CITY OF WESTMINSTER			
PLANNING APPLICATIONS COMMITTEE	Date 24 November 2015	Classification For General Release	
Addendum Report of Director of Planning		Wards involved St James's	
Subject of Report	40 - 41 Pall Mall, London, SW1Y 5JG		
Proposal	Demolition of 40 and 41 Pall Mall behind retained facades and redevelopment to provide a building of basement, ground and five upper floors comprising retail (Class A1) at part basement and part ground floor levels with the remainder of the building in use as four self-contained residential flats (Class C3).		
Agent	Savills		
On behalf of	Pall Investments Ltd		
Registered Number	14/10618/FULL	TP / PP No	TP/10116
Date of Application	24.10.2014	Date amended/ completed	17.12.2014
Category of Application	Minor		
Historic Building Grade	Unlisted		
Conservation Area	St James's		
Development Plan Context - London Plan July 2011 - Westminster's City Plan: Strategic Policies 2013 - Unitary Development Plan (UDP) January 2007	Within London Plan Central Activities Zone Within Central Activities Zone

40-41 PALL MALL, SW1

Demolition of 40 and 41 Pall Mall behind retained facades and redevelopment to provide a five storey building comprising retail (Cl

Fourth Floor Plan
 As Proposed

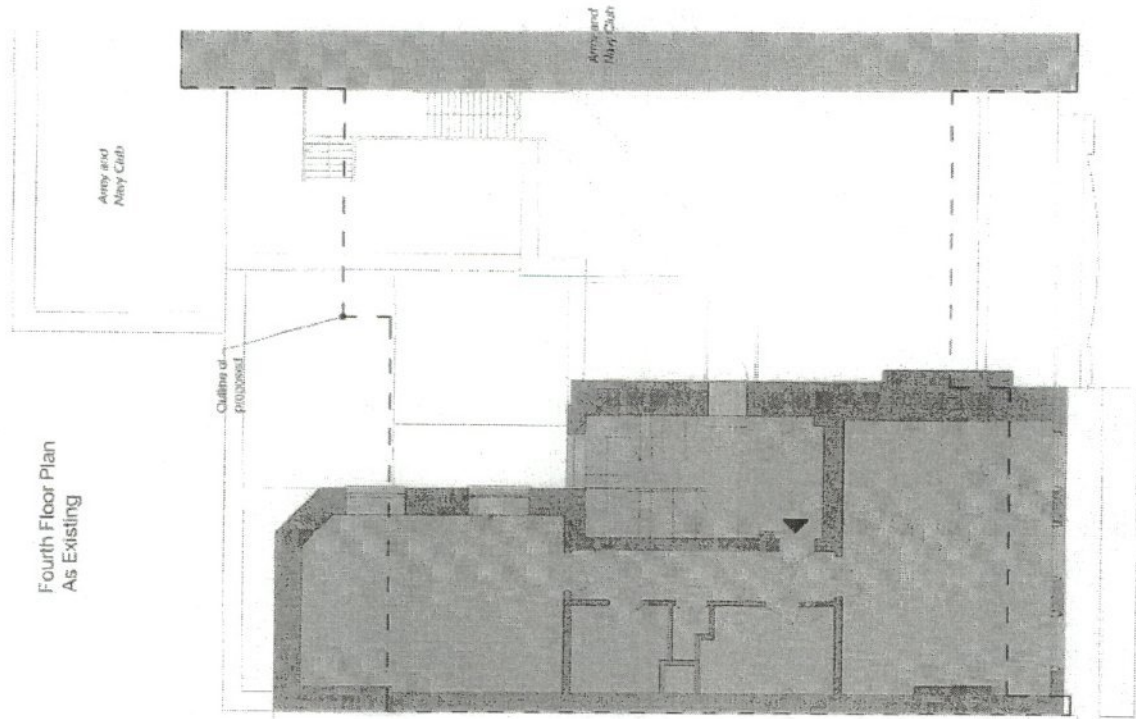
- a) Improving the window design at the rear third and fourth floors to minimise overlooking.
- b) Making provision for retaining the cafe.
- c) Reducing bulk at the rear of the proposed building to minimise the impact on the Army and Navy Club.

In terms of the bulk and massing, the applicant has set back the rear of No. 40 by approximately 3.5m at fourth floor level and by approximately 2m at fifth floor level. It is understood these setbacks have been made in agreement with the Club. The height and bulk of the replacement building remains acceptable in design and amenity terms.

Since the Committee's resolution the scheme has been amended to adjust the rear windows within the closet wing of No.41 at third and fourth floor levels so that they are partially obscured and angled away from the club. At fifth floor level the windows are set back from the rear building line as before and a new obscured glass privacy screen has been incorporated to the parapet of the closet wing of No.40 to prevent overlooking to the Club terrace.
